Service Bulletin

Bulletin No.: 24-NA-019
Date: February, 2024

Subject: Roof Rail Gap

Brand:	Model:	Model Year:		VIN:		Engine:	Transmission:
		from	to	from	to		
BrightDrop	Zevo 400	2024	2024	-	-	All	All
	Zevo 600	2023

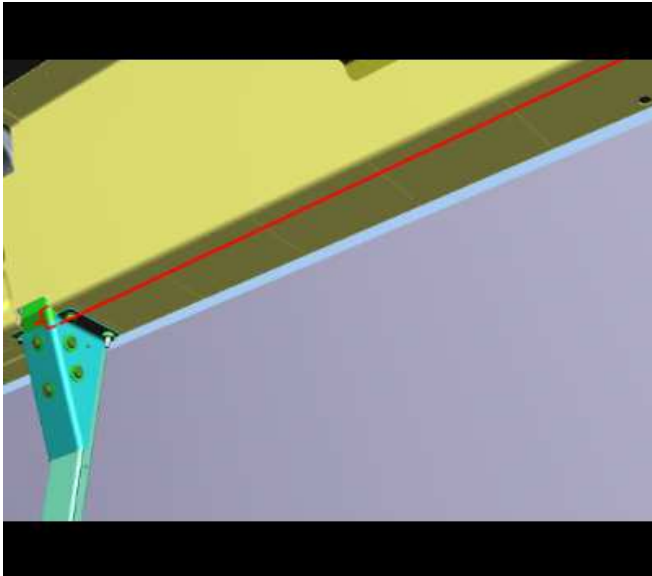
Involved Region or Country	North America	
Condition	 6531963 Some customers may comment on a gap in the roof rail.	
Cause	The cause of the condition may be a build quality concern.	
Correction	Install rivets by following the procedure outlined below.

6531966

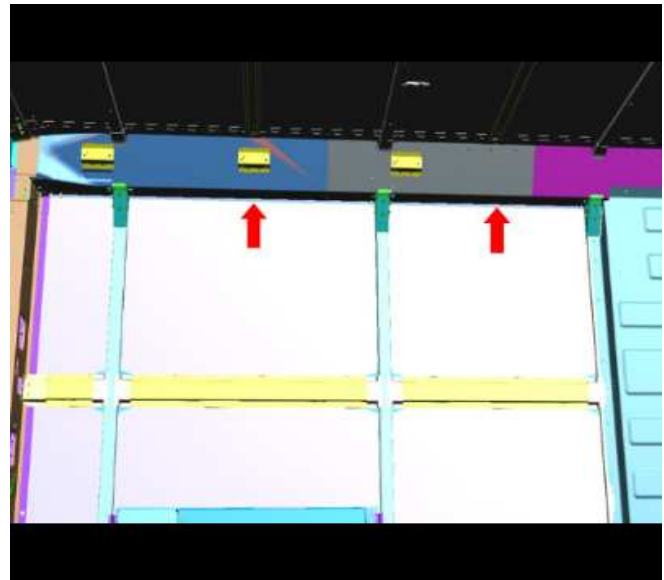
1. Mark a line down the rail 20mm (2.2 cm) from the edge of the rail.

6531968

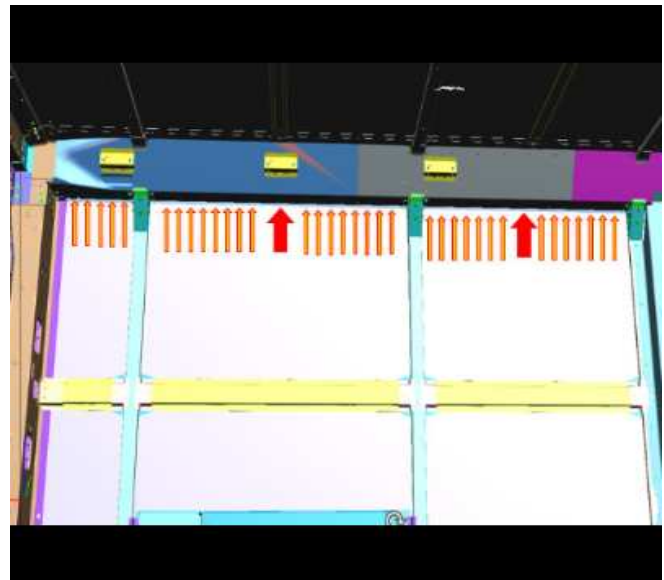
2. Locate the center of the vertical supports and mark it.

6531969

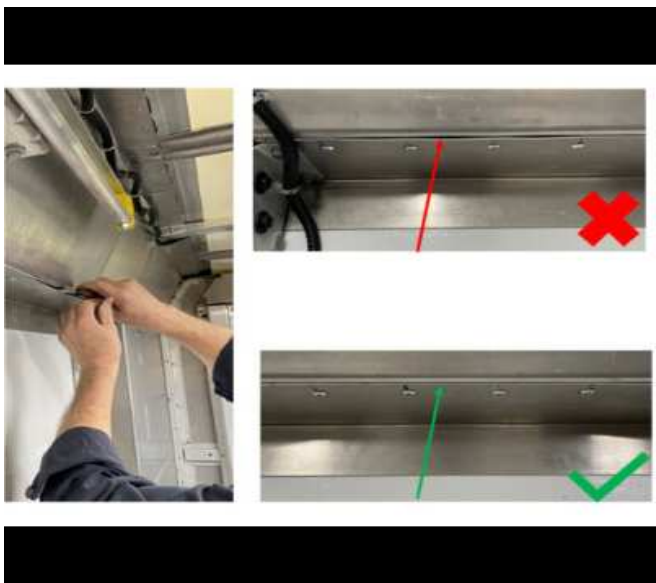
3. Mark 75mm from the center mark on both left and right sides. Continue marking every 75mm until the vertical strainer has been reached.
4. Drill 6.7mm (.67cm) (17/64") hole at each mark.
